McLaren Speedtail – Filler Flap Operation Enhancement

Bulletin type:	Service Campaign
Reference number:	N/A
Campaign reference:	SCB 23 A 001
Attention:	Retailer Aftersales Managers, Retailer Service Managers, Retailer Service Advisors, Retailer Technicians, Retailer Parts Managers
Affected vehicles:	McLaren Speedtail
Situation:	Replacement of the fuel and oil flap push-push mechanism rubber caps with new plastic version
Procedure:	Action affected vehicles during next Retailer visit. Please refer to the information outlined in this document to complete the required rework
Date:	14 September 2023

Image 1: Location of the filler flap plastic cap

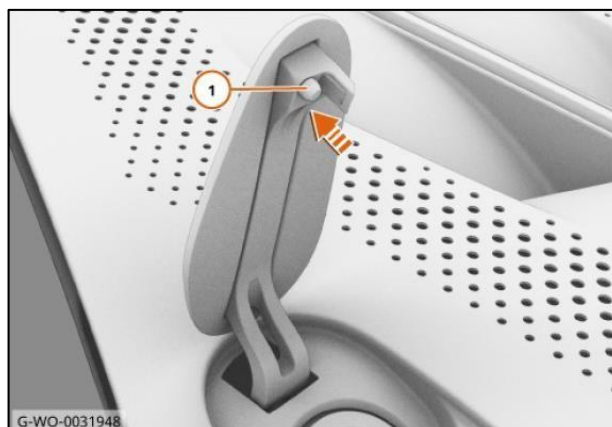
Through continuous product quality monitoring, McLaren Automotive has identified that the rubber caps of both the filler flap mechanisms can deform over time and prevent them from opening. To address this, McLaren Automotive, has released a solution which includes a new plastic cap which needs to be fitted to each of the fuel and oil filler flaps in place of the old caps.

The below part is required to action this rework and can be ordered in the usual way via Unidial 2. Two new caps are required per vehicle. One of each to be fitted to the fuel and oil filler flaps.
